**Damaged Wiring Harness – Possible Intermittent Engine Misfire/No Start – Remove Harness Clip**

MODEL 1995-96 MY  
Sedan Range  
VIN  
720001-770946

ILLUSTRATION 1

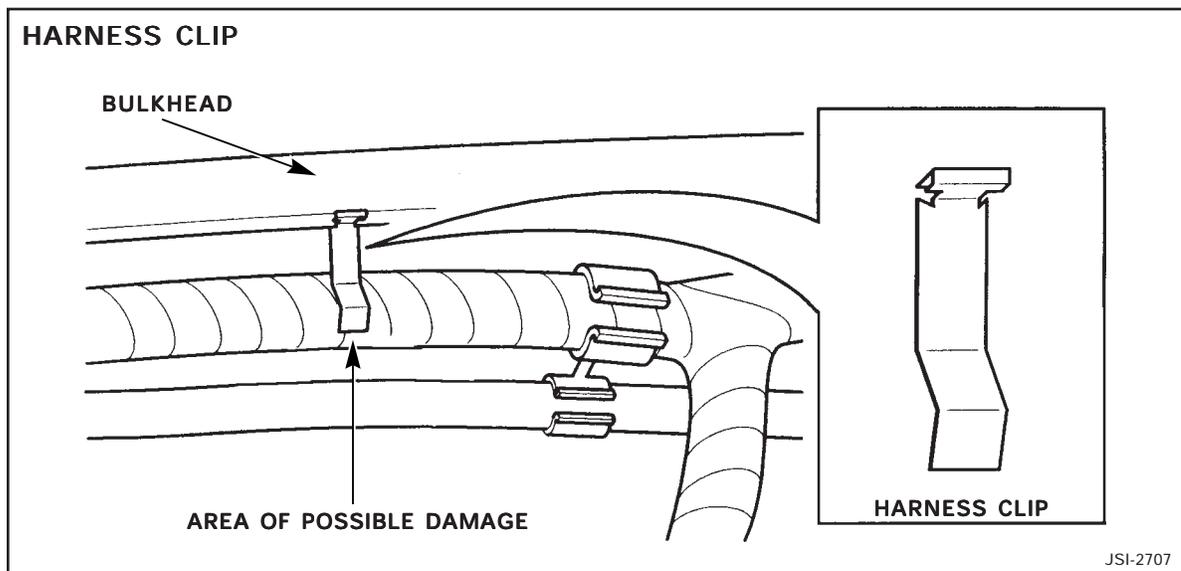
Some Sedan Range vehicles within the above VIN range may exhibit a condition of engine misfire/no start, which can be caused by a clip shorting the engine management harness to ground. The clip, which is located on the bulkhead on the right side of the engine compartment (Illustration 1), may cut into the harness causing a short circuit.

The clip is not found in this location on all vehicles and was deleted from the vehicle build specification after VIN 770946.

Remove and discard the clip on all vehicles where it is found, to eliminate the possibility of it penetrating the harness.

In case of a customer complaint of engine misfire/no start, check if the clip is present and if it has penetrated the harness. Remove and discard the clip. Test to verify if the harness has been damaged and repair as needed.
